T2D: Consultation on community open space

Bike Adelaide is the leading voice engaging with governments on cycling for transport across Greater Adelaide on an ongoing basis. We appreciate the opportunity to provide feedback regarding the Torrens to Darlington project's proposed urban design, in relation to the many new open spaces being delivered as part of the project.

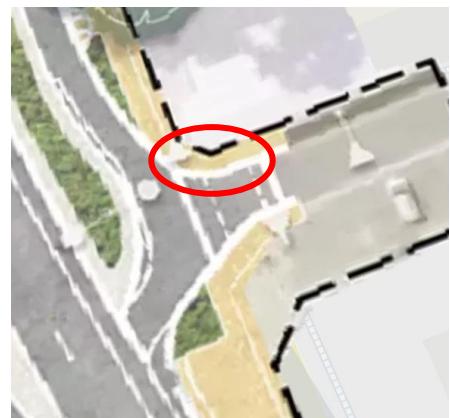
- 1) The right turns via a large traffic island at Anzac Highway effectively operate as large slip lanes, with vehicles crossing the bike lane and footpath alignment on South Road. Given the similarity to interchange off-ramp design, it is likely they will expect to have priority at South Road. They will also be able to maintain relatively high speeds while using these turn lanes.

On the western side, southbound cyclists crossing this turn road essentially need to yield to right turners coming from behind, and northbound cyclists to left turners coming from behind; and similarly for the eastern side, with southbound cyclists yielding to left turners and northbound cyclists yielding to right turners coming from behind them. This is not desirable.

For the safety of pedestrians and cyclists, the shared paths on South Road should have pedestrian actuated crossings. As right turn vehicles will only be using their turn lanes when they've been released through the traffic lights at Anzac Highway, the phasing could be linked to the traffic lights to allow right turn vehicles to go through unimpeded after getting the green at Anzac Highway. For left turners, a realignment of the paths to provide extra storage between the shared path crossing point/new pedestrian actuated crossing and South Road would be both desirable and possible.
